SB-GA8-2005-24 Issue 1

Service Bulletin

Alternator Cooling System Upgrade.

Figure 2

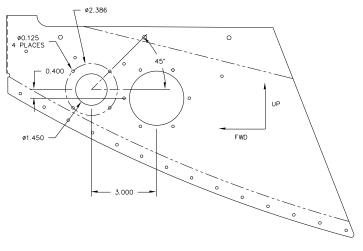
- 1.4. Disconnect the alternator from the electrical system and remove from the engine with cooling duct.
- 1.5. Block or remove the cooling blast tube from the front engine baffle. If the tube is removed the gap in the cowl must be blocked by a new piece of baffle rubber. If the tube is blocked consideration must be given to water being trapped in the tube.
- 1.6. Modify the oil cooler RH side baffle to add 1.45" diameter hole and rivet pattern as per figure 1.
- 1.7. Apply a suitable quantity of neutral cure silicon sealant to the faying surface of the filter mesh GA8-716021-101 (item 2), and install spigot GA8-713022-59 (item 1) and filter mesh to baffle using TLED 435 rivets (item 10). Refer to figure 2.

Figure 3

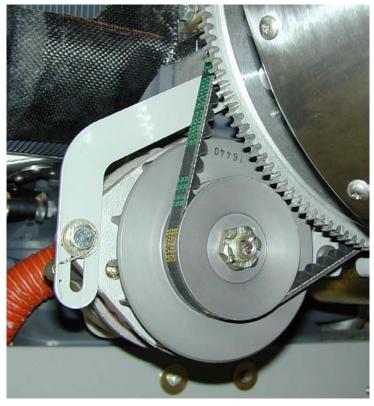
- 1.10. Remove existing fibreglass shroud from alternator and install new fibreglass shroud GA8-242027-11 (item 6).
- 1.11. Install modified alternator back onto the engine using the same hardware as used for the previous alternator.
- 1.12. Tension the alternator belt in accordance with Lycoming Service Instruction No.1129B as per Section 24-00-55 of the GA8 Service Manual. Lockwire the bolt securing the alternator stay to the alternator body in accordance with FAA publication AC 43.13-1B refer to Figure 3.
